- A. Mere 402M and 500M Shift Interlock Spring Removal
- B. Lubrication of Merc 1750 Transom Mounting Bolts
- C. Hose Clamp Location Merc 850 Fuel Pump
- D. Control Removal from Mercury Outboard Carton
- E. Exhaust Relief Ports Merc 110-75-45

# Figure 1. Toggle Spring Location

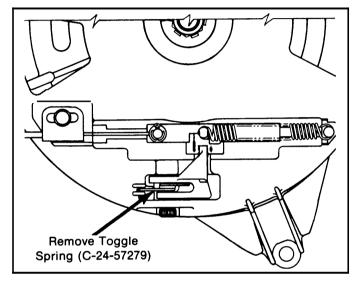
Merc 402M and 500M Outboards incorporate a shift interlock which allows the rewind starter to operate in neutral position only. At times, Mercury Marine has received complaints of the interlock jamming up and not allowing the rewind starter to operate. To prevent the interlock from jamming, remove toggle spring (C-24-57279). (Figure 1) Merc 1977 models do not have the toggle spring installed.

Figure 4. Cutting Carton

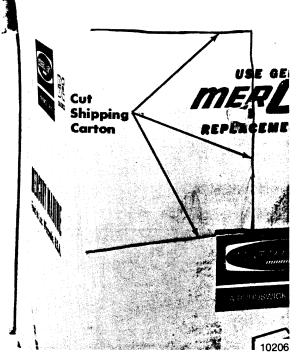
Many Mercury Outboard dealers remove the remote control from the outboard carton to pre-rig boats. Starting with 1977 Power Trim models (Serial No. 4603762 and up), remote controls are packaged in a box and inserted into the outboard carton. To remove remote control from carton (for pre-rigging), cut the carton as shown in Figures 4 and 5. Carton must be cut on the rear side only to remove control.

Figure 6. Drill Hole Location

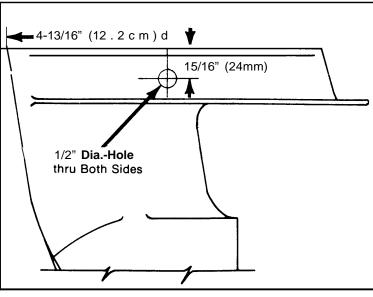
Occasionally, maximum reverse thrust is required on an installation such as an auxiliary engine on a sailboat or other heavy displacement hull. To obtain this maximum reverse thrust, drill two 1/2''(12.7mm) diameter exhaust relief holes in the gear housing, as shown in Figure 6.

Tests conducted on Merc 110-75-45 models indicate that reverse thrust could be approximately doubled by drilling the relief holes.

Merc 110-75-451977 Models have a "dimple" in the gear housing at the above location for ease in drilling.
